Addendum No. 1

Issued: February 23, 2021

Project: Cranbury Public Library

ARCHIVES STORAGE ROOM DRY CHEMICAL SUPPRESSION PLAN AND DETAILS

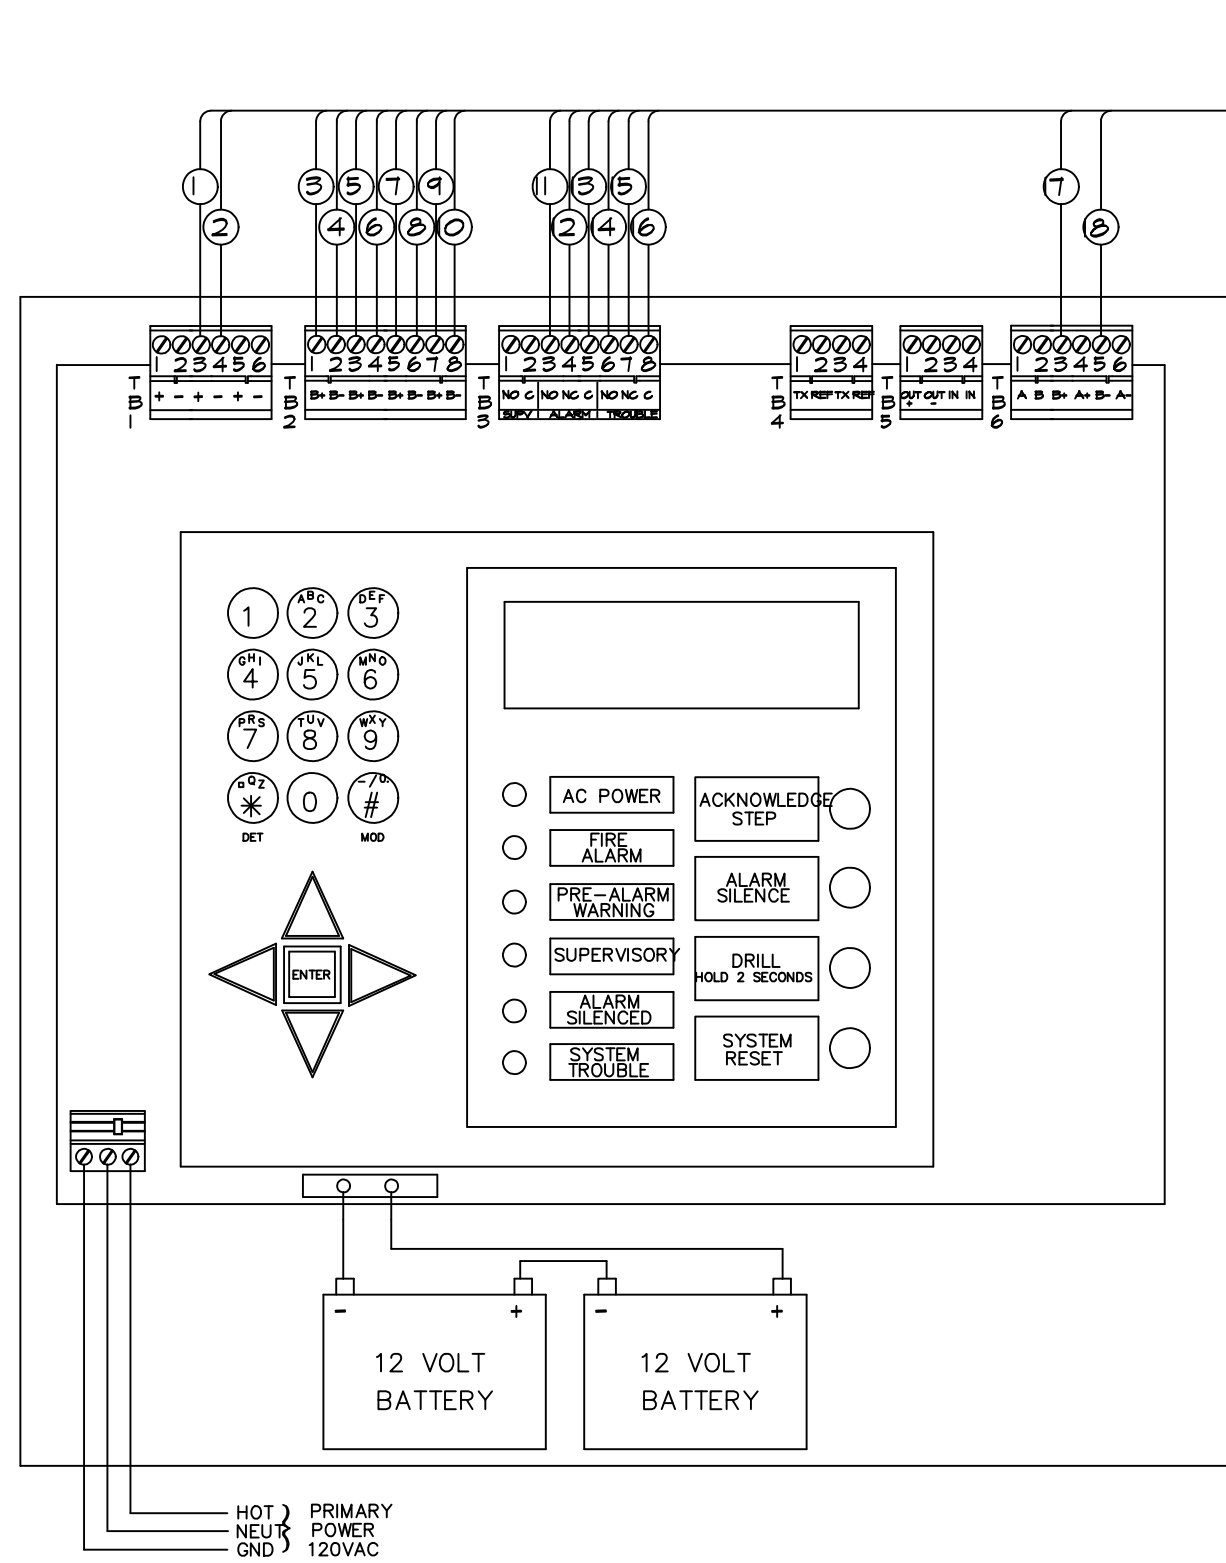
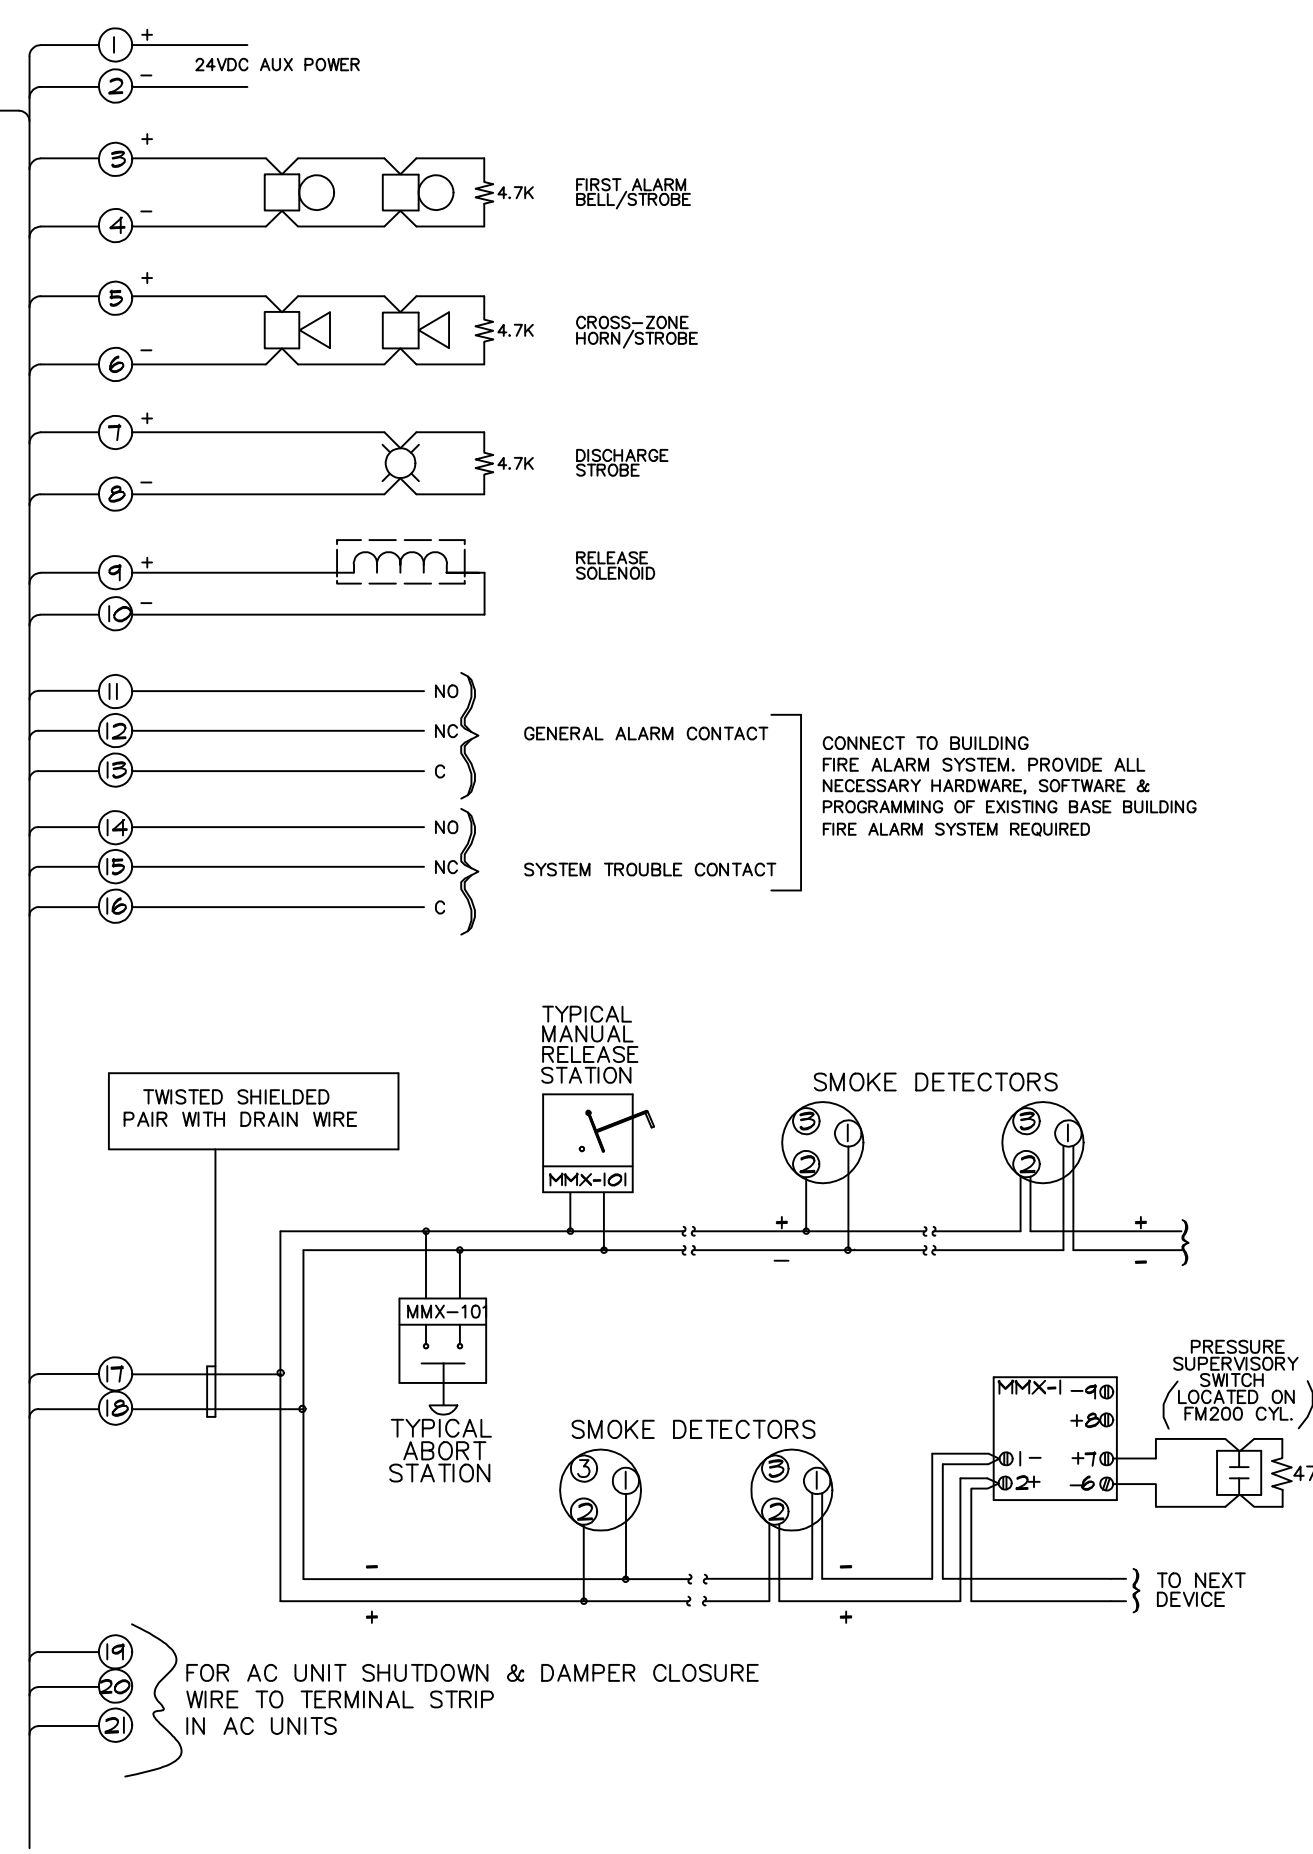
- Item #8: ***Drawing E.100 Electrical Lighting Schedules and Details*** – Eliminate the (2) remote battery back-ups shown in Women's 121.
- Item #9: ***Drawing FP.100 Archives Storage Room Dry Chemical Suppression Plan and Details*** – The specified system and design is intended for installation in History 110. Revise Drawing Name from “*Archives Storage Room Dry Chemical Suppression Plan and Details*” to “*History 110 Dry Chemical Suppression Plan and Details*”. Replace Clean Agent Fire Suppression System Scope of Work Note #1 with “*1. Design, Furnish and install a complete operational FM200 fire suppression system for History 110 along with but not limited to the following:*” Refer to attached revised *Drawing FP.100 Archives Storage Room Dry Chemical Suppression Plan and Details*.
